**DEFENSE NUCLEAR FACILITIES
SAFETY BOARD**

January 20, 2012

Staff Issue Report

SUBJECT: Erosion/Corrosion Wear Allowances, Waste Treatment and Immobilization Plant

Figure 1. Comparison of experimentally determined wear rate data based on depth measurements with the WTP design basis wear rate for vessels with pulse jet mixers.

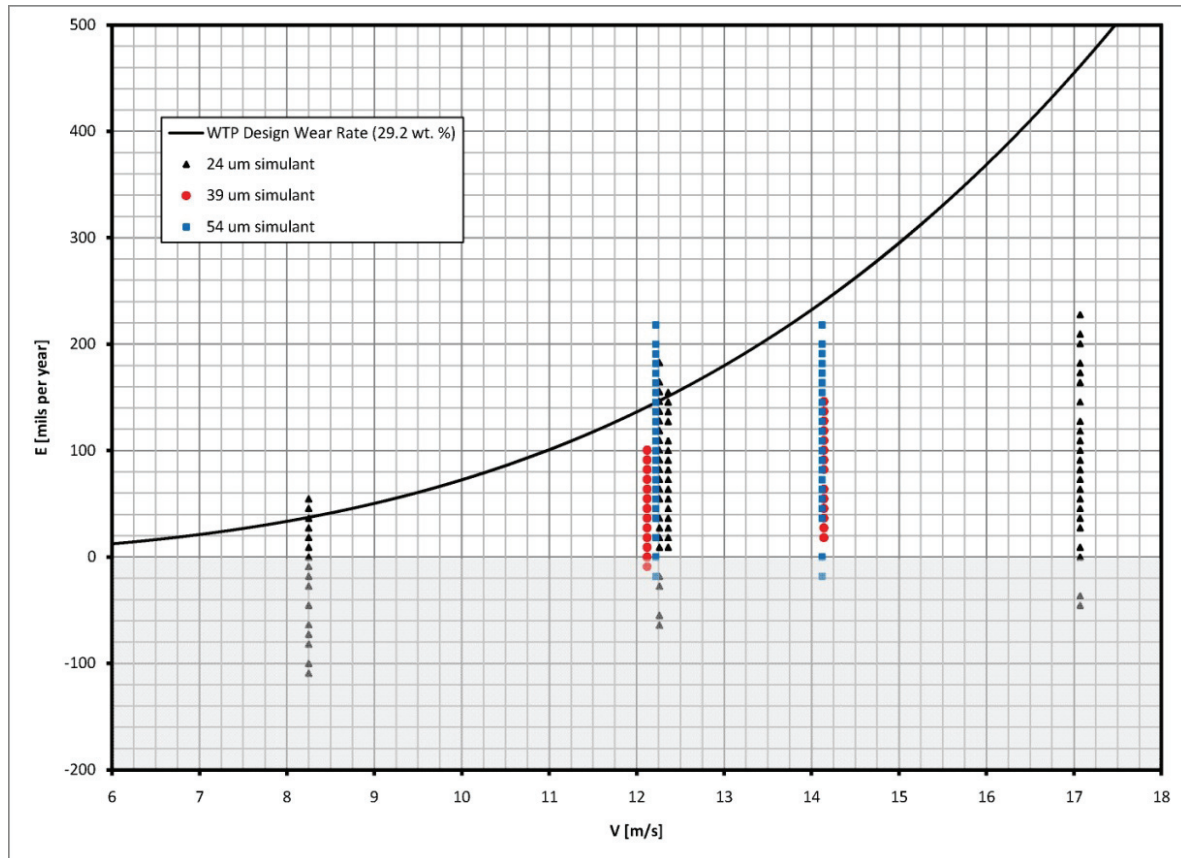
Measured Wear Is Higher Than Design Wear Rate—Figure 1 shows a subset of the data collected during the testing to close EFRT Issue M2. The plot shows the measured erosion rate (E) based on depth measurements as a function of velocity (V). Each datum on the plot represents the wear rate derived from depth measurements made at one of thirteen predetermined locations on each wear specimen. Each wear specimen was exposed to 96 hours of submerged

A substantial number of the localized wear data measurements for velocities of interest (8–12 m/s) for WTP PJM nozzles and vessel bottoms, including those obtained using the nonbounding but representative 24 μm simulant, lie above the curve that defines the design basis wear rates for WTP vessels and piping. Some of the measured data are 30 percent above the design basis wear rate. Consequently, the relationship used to define design wear rates for the vessels and PJMs does not provide sufficient conservatism.

Test Duration and Measurement Methods Cause Substantial Uncertainty—The short-duration used for the above testing (96 hours) did not cause enough wear to permit accurate measurement of localized wear. In many cases, the resulting wear was close to or less than the accuracy of the instrument used to measure the wear. The result was unreliable measurements and, as shown in Figure 1, large data scatter. The staff analyzed the data and found that the mean difference between independent measurements performed by two different analysts was 0.23 mils with a standard deviation of 0.18 mils (which corresponds to a mean difference and standard deviation of 21.1 and 16.4 in mils per year [mpy], respectively). This error is substantial considering that, as shown in Figure 1, the expected wear for 8 m/s flow is 40 mpy.

As a further indication of uncertainty, data collected at a flow rate of 8 m/s displayed a scatter over a range of -115 mpy to +55 mpy. Data collected at 12 m/s scatter over a range of -65 mpy to +220 mpy. There is no discernable pattern or trend in the data. The experimental data that suggests a negative wear rate (gray region in Figure 1) are physically unrealistic (i.e., indicate that the wear coupons were increasing in thickness during testing).
